ADDENDUM NO. 2

December 9, 2022

BAILLY ELEMENTARY SCHOOL ADDITIONS AND RENOVATIONS Chesterton, IN 46304

Addendum Two (AD.02) to the drawings and specifications prepared by Gibraltar Design for **Bailly Elementary School Renovations** for Duneland School Corporation, Chesterton, Indiana.

© GIBRALTAR DESIGN SHEET
E MP105

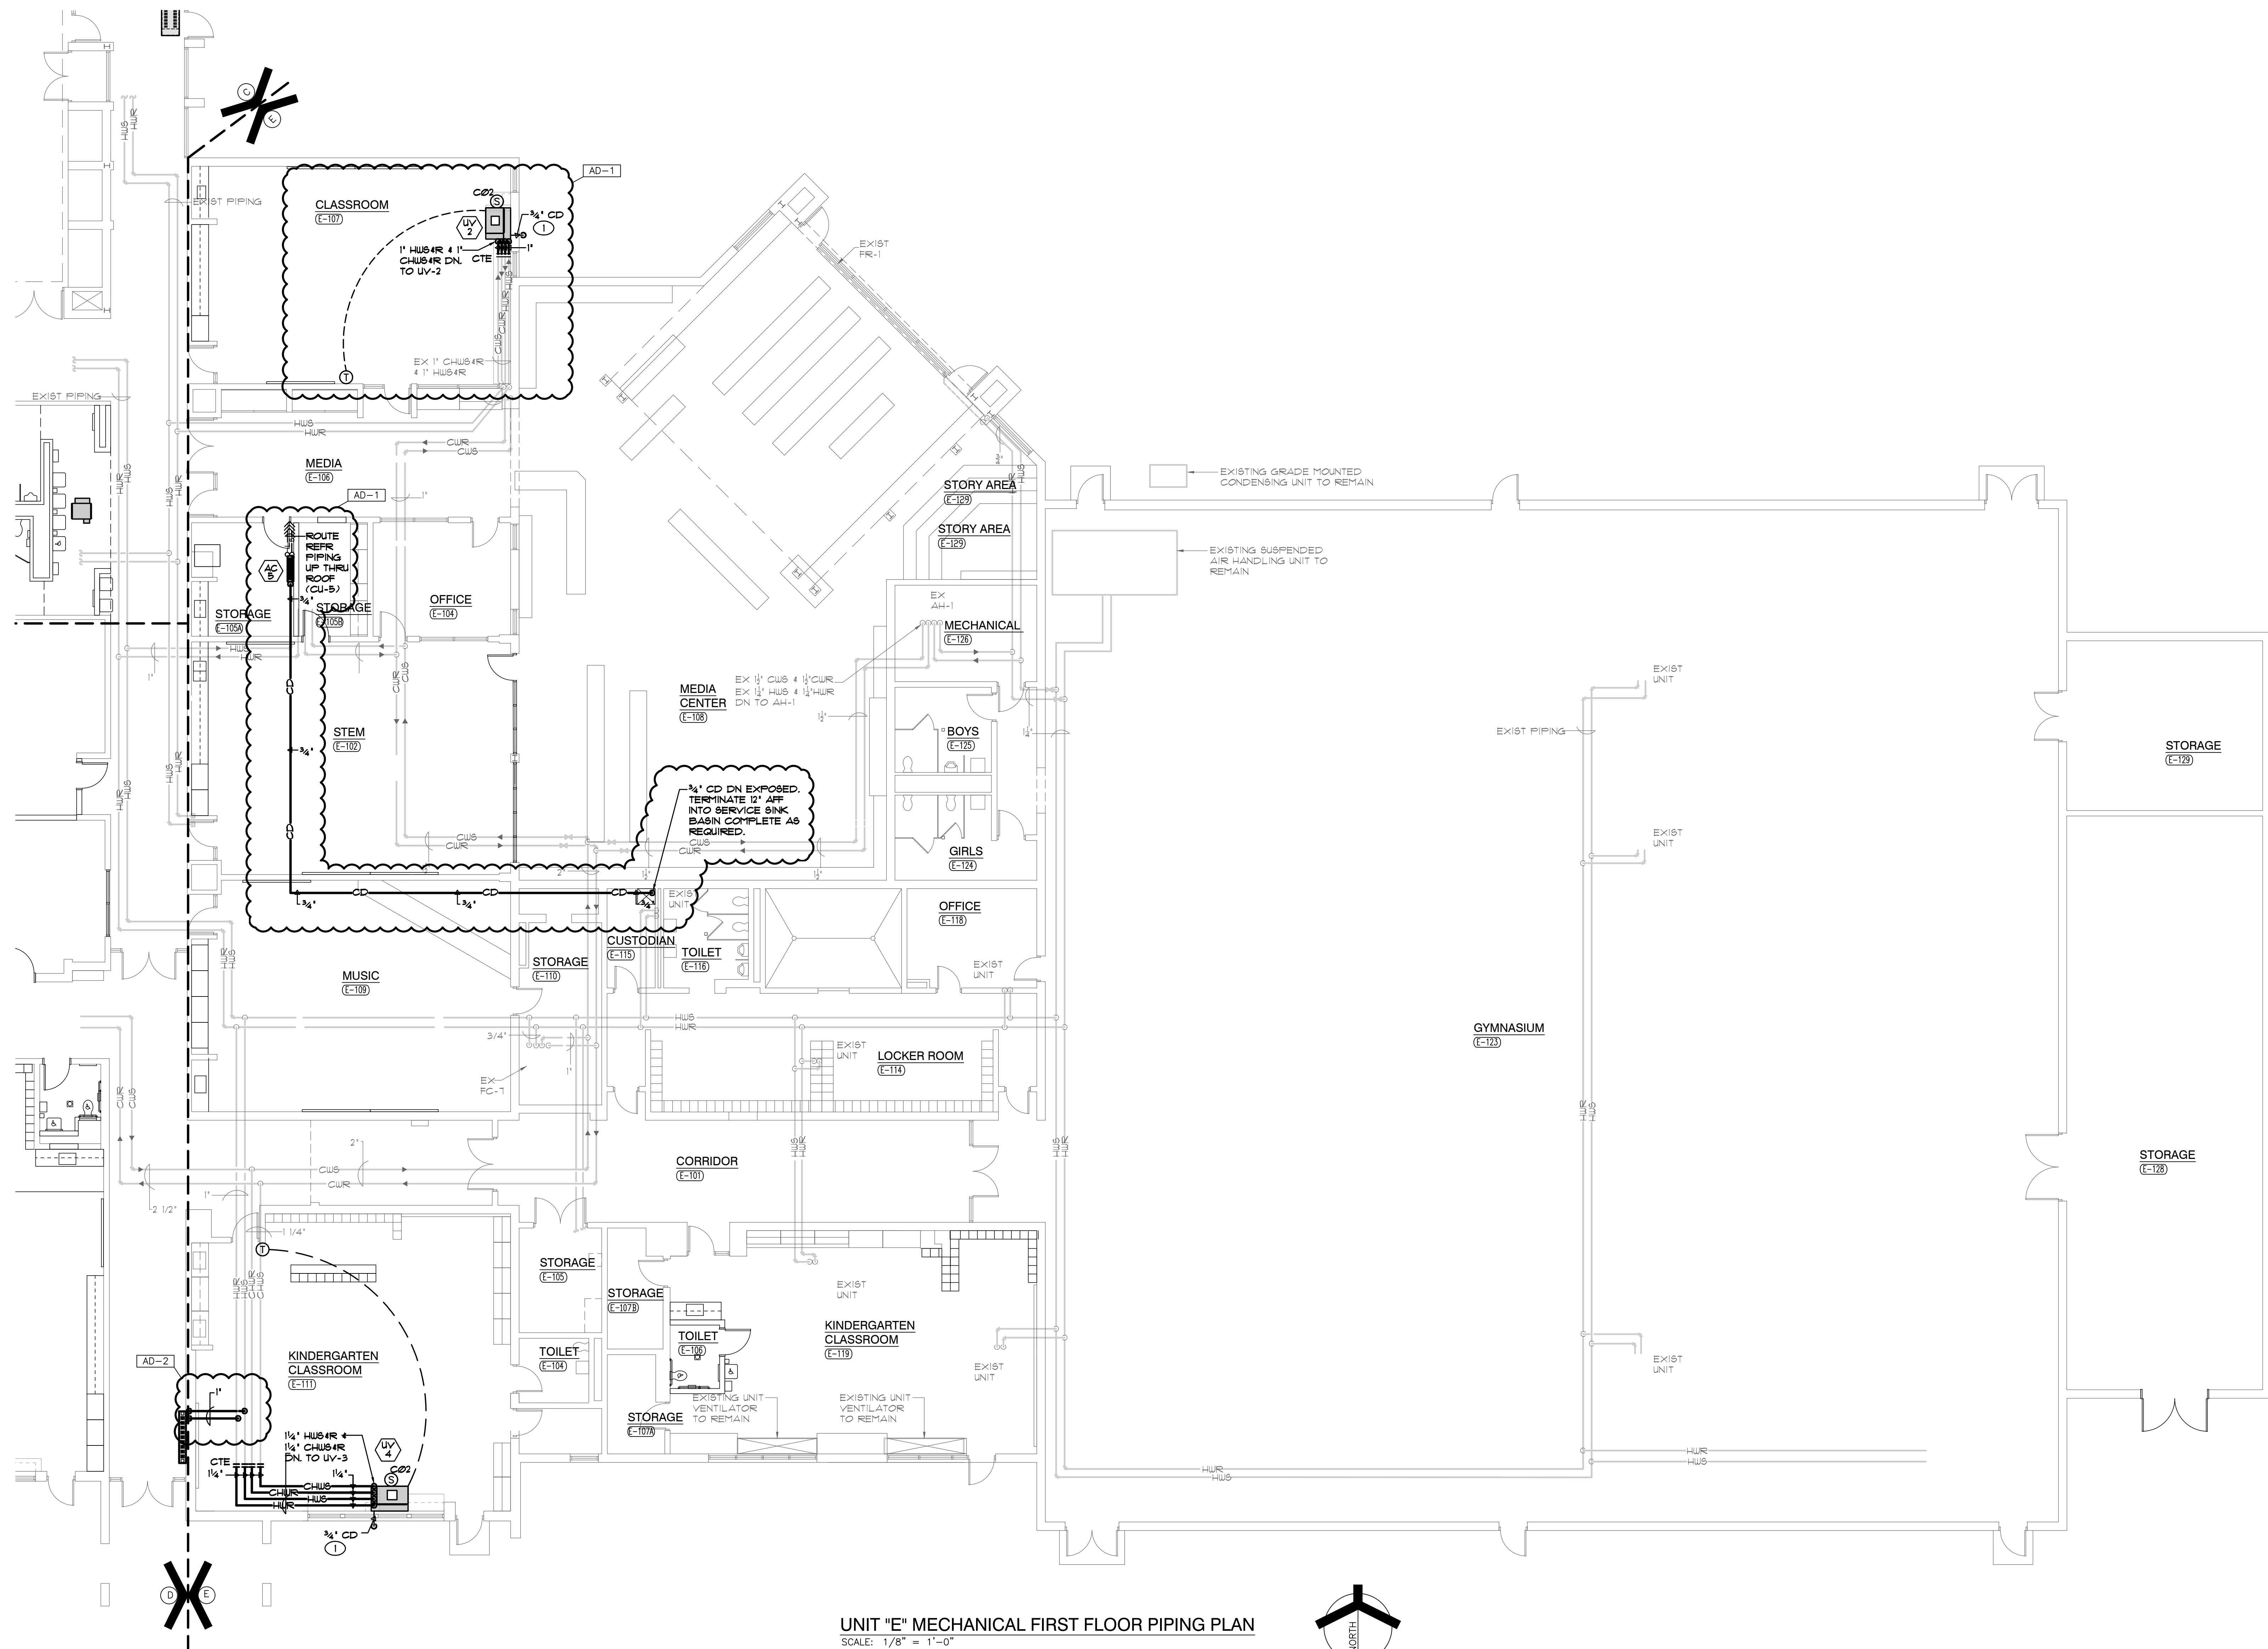
- A. Refer to revised full size drawing included in this addendum for revised new HWS&R piping.

ELECTRICAL SYMBOL LIST

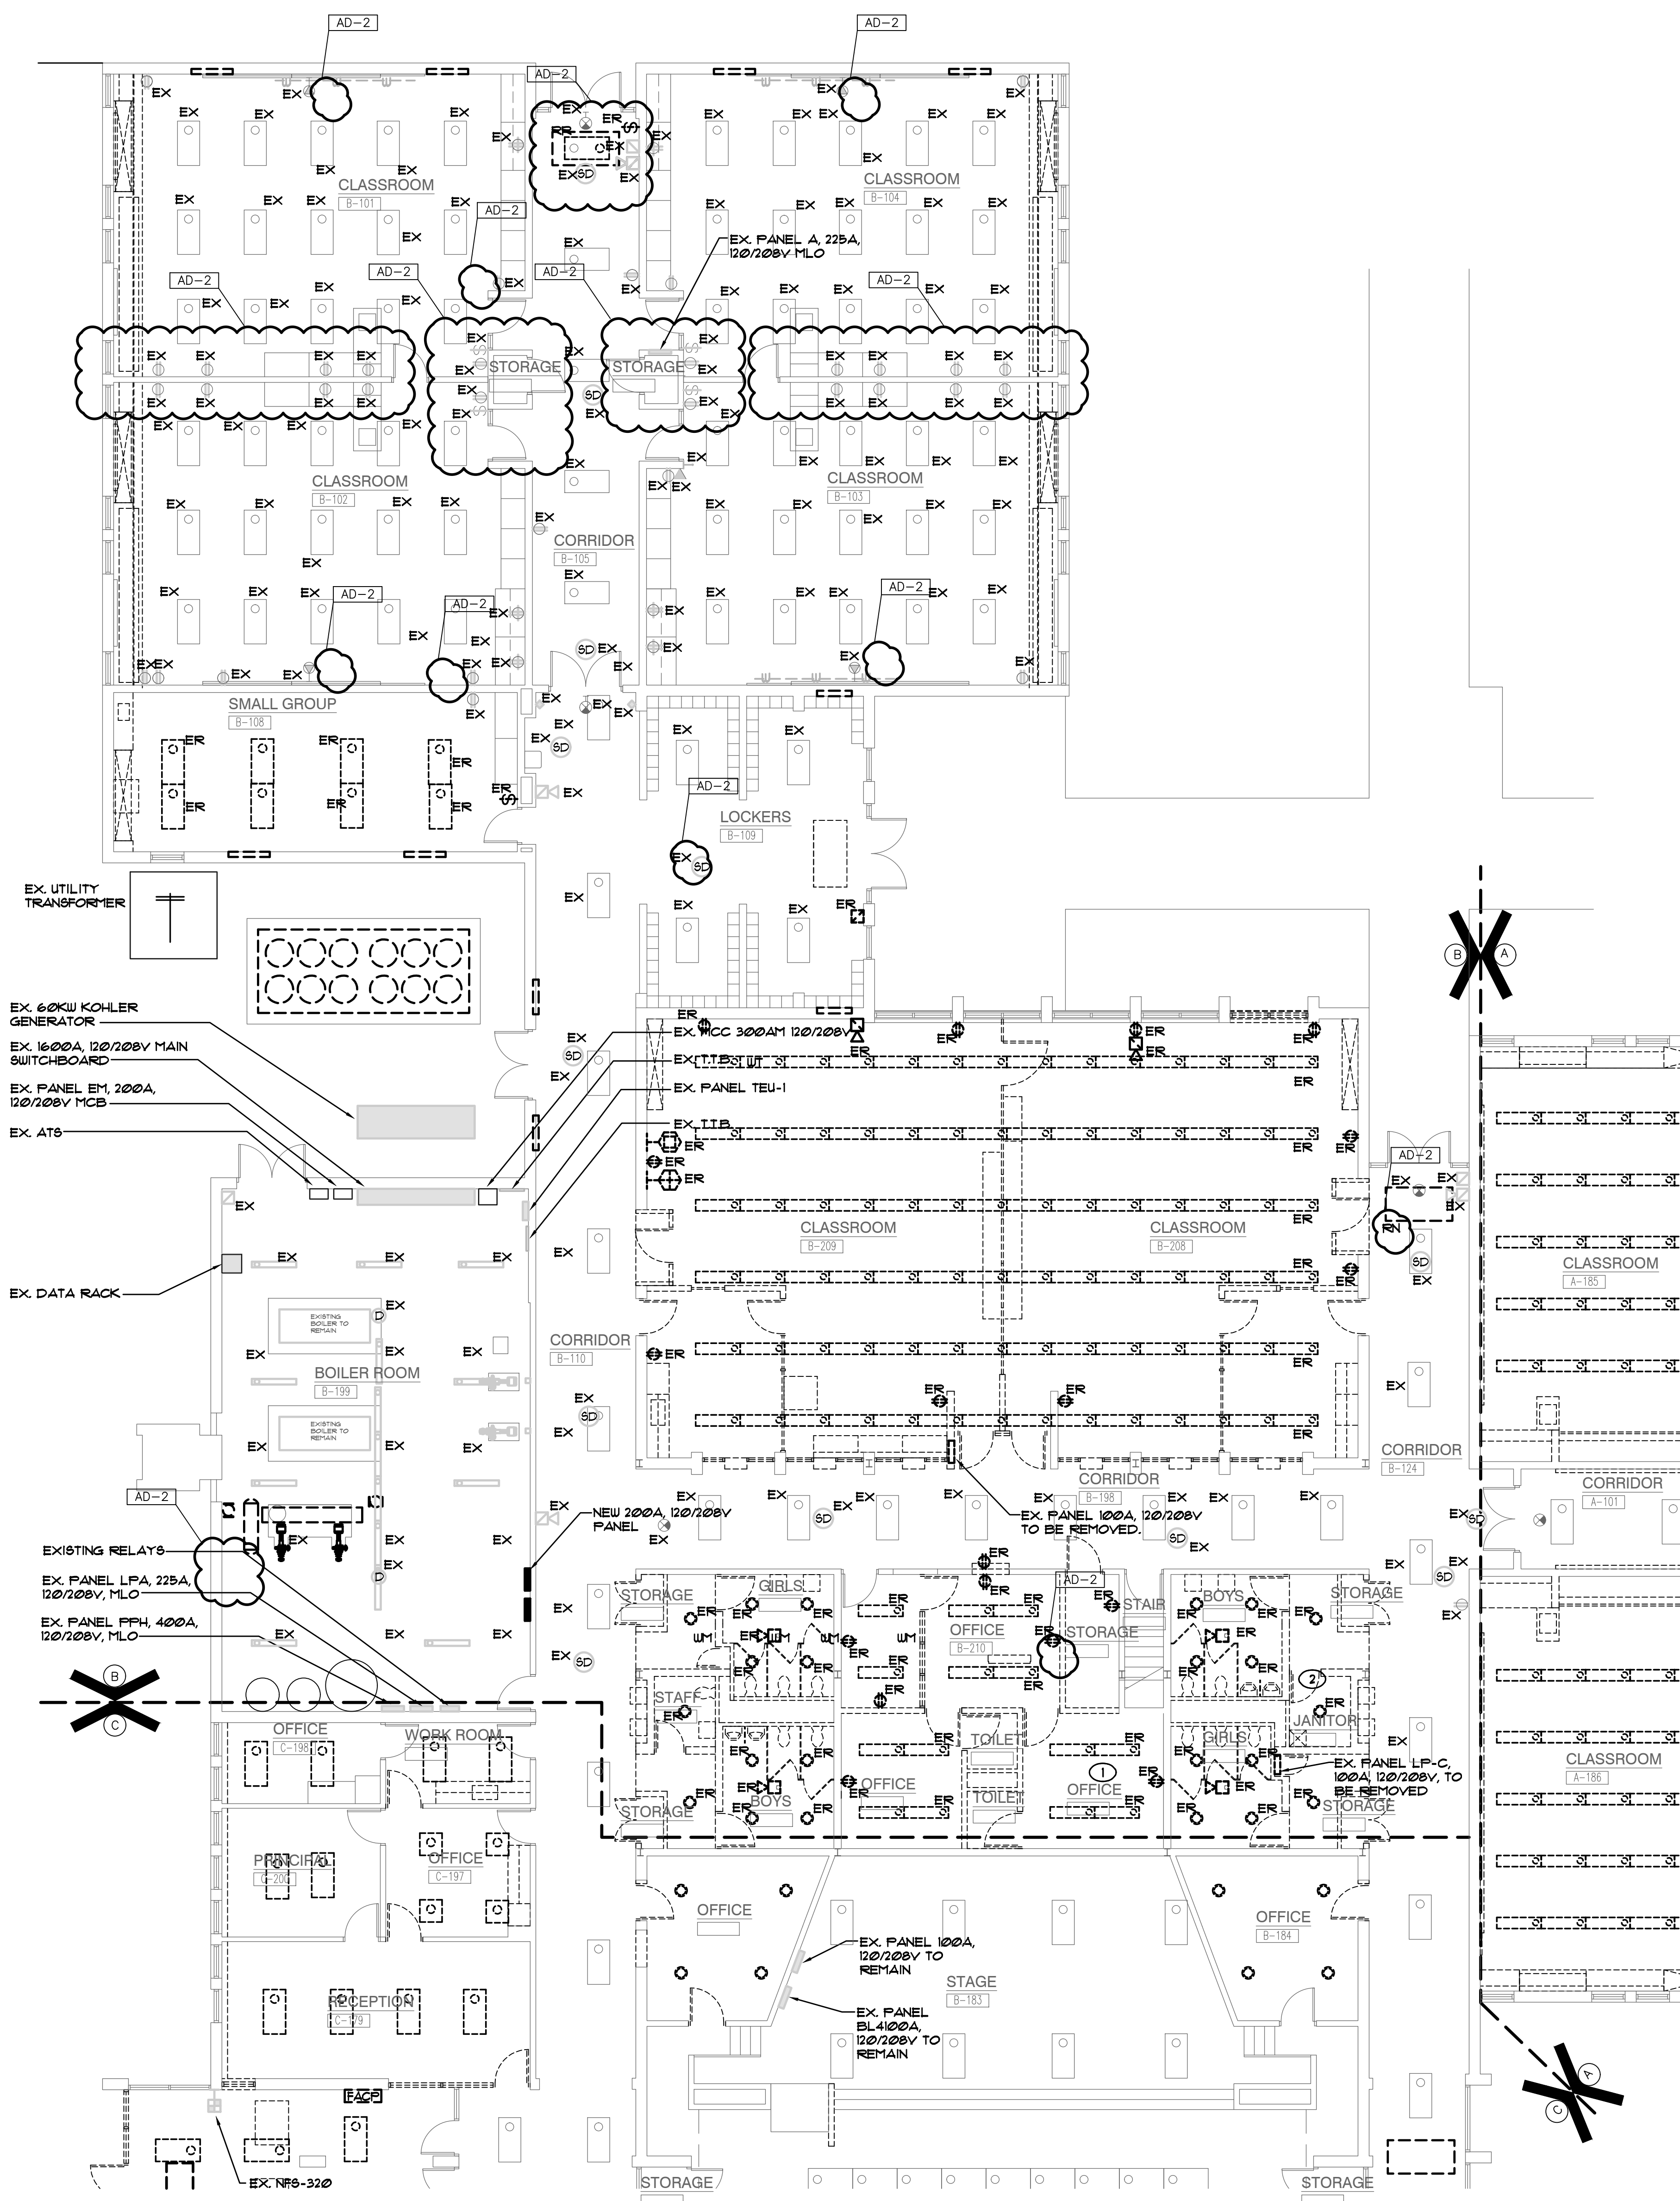
- A. Refer to revised full size drawing included in this addendum for the following revisions:
 - 1. Added symbol designations and associated requirements for device subscripts.
